**Release Notification and Corrective Action**

Name of Company: WPX Energy Inc/RKI <i>241289</i>	Contact: Karolina Blaney
Address: 5315 Buena Vista Dr.	Telephone No.: 970 589 0743
Facility Name: RDU 34 well pad	Facility Type: Well Pad

**RE: Remediation Work Plan Addendum  
Ross Draw Unit #034  
Incident Numbers nAPP2107554265, nAB1736055339 (2RP-4529) and nAB1528240224  
(2RP-3322)  
Eddy County, New Mexico**

CONDITIONS  
 Action 61866

Figure 1 Site Location Map  
Attachment 1 Referenced Well Records

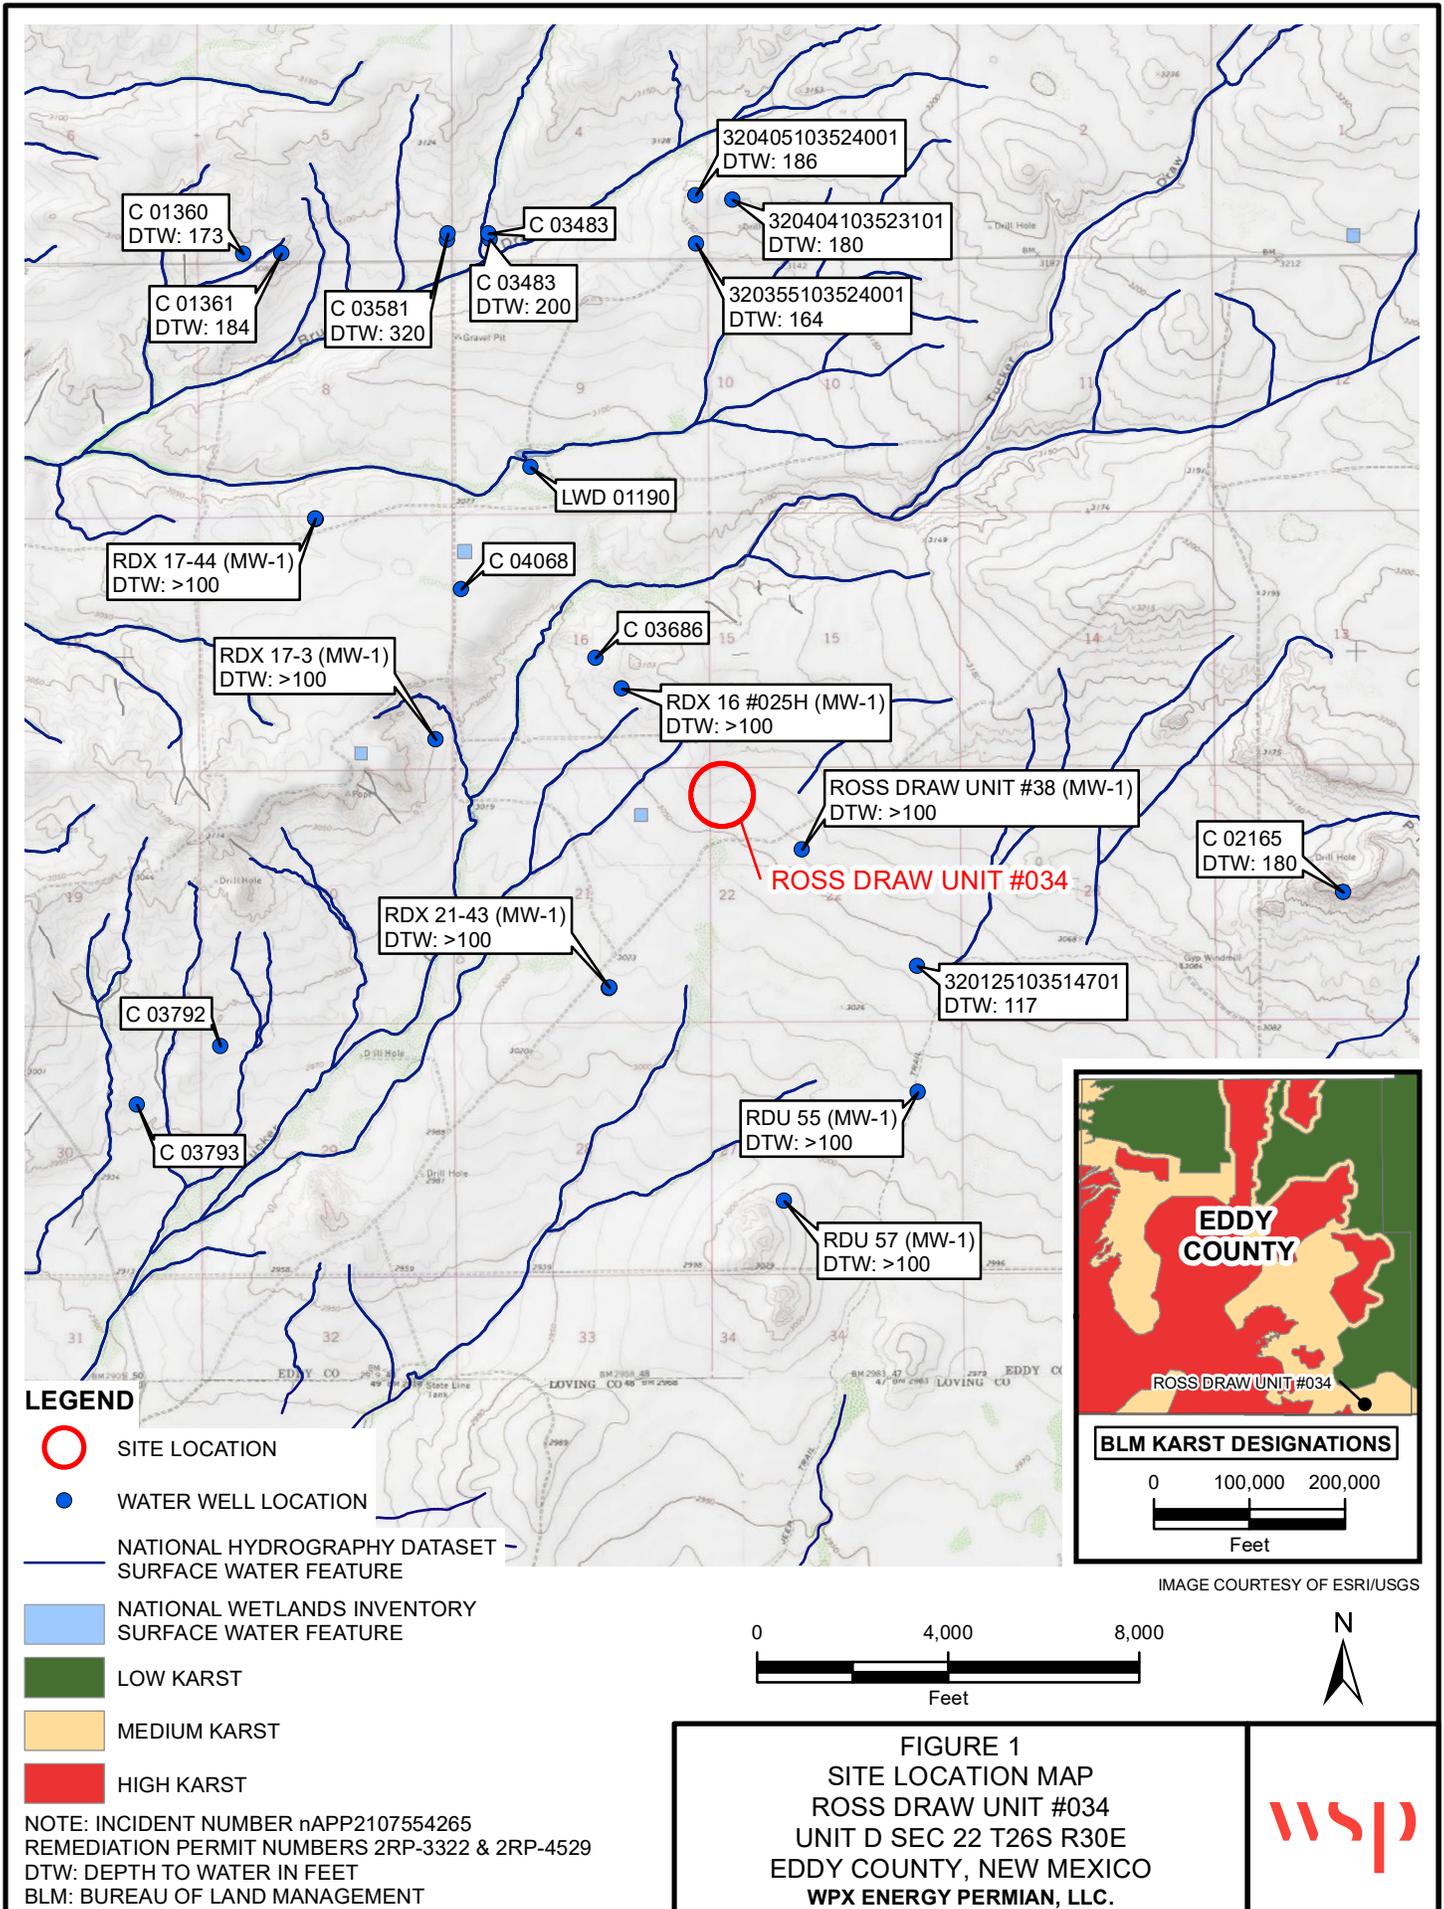
NMOCD emailed Mr. Jim Raley with WPX on August 19, 2021 indicating their denial of the May 2021 Remediation Work Plan Request based on the following:

- *When nearby wells are used to determine depth to groundwater, the wells should be no further than ½ mile away from the site, and data should be no more than 25 years old, and well construction information should be provided. If evidence of depth to ground water within a ½ mile radius of the site cannot be provided, impacted soils will need to*

*meet Table 1 Closure Criteria for ground water at a depth of 50 feet or less. The Closure Report is denied due to inadequate and unapproved sampling plan.*

As indicated in the original Remediation Work Plan Request, depth to groundwater at the Site is estimated to be greater than 100 feet bgs based on soil boring MW-1, associated with Ross Draw Unit (RDU) #38, that was drilled by Talon LPE on December 8, 2020. The soil boring is located approximately 0.36 miles southeast of the Site (32.030491°, -103.871260°). Using a truck mounted drill rig equipped with hollow stem auger, the soil boring was advanced to a total depth of approximately 105 feet bgs. Groundwater was not observed within the soil boring after at least 72 hours. Following the observation period, the boring was plugged and abandoned. The boring log is included as Attachment 1.

In addition, WPX installed six other borings in December 2020 (RDX 16 #25H (MW-1), RDX 21-43 (MW-1), RDX 17-3 (MW-1), RDX 17-44 (MW-1), RDU 55 (MW-1), and RDU 57 (MW-1)) within a 3-mile radius of the Site and depth to water results for all six indicated groundwater was not encountered within 105 feet of the ground surface. Two other water wells, United States Geological Survey (USGS) well number 320125103514701 and New Mexico Office of the State Engineer (OSE) well number C 02165, indicate depth to water was 117 feet bgs and 180 feet bgs, respectively. Regionally, depth to water appears to be greater than 100 feet bgs and therefore the depth to water estimate for RDU #38 appears to be consistent with the regional data, thus a representative water well for estimating depth to water for the Site. Figure 1 depicts the nine water wells described above.

<b>Depth to Water Criteria</b>	<b>Response – Water Well RDU #58 (MW-01)</b>
Well located within ½-mile of the Site	Approximately 0.36 miles from the Site
Depth to water measurement within the last 25 years	Well drilled and depth to water measured in December 2020
Well Construction Provided	The boring log and well construction information was provided in the original Remediation Work Plan Request and included in Attachment 1 of this Addendum
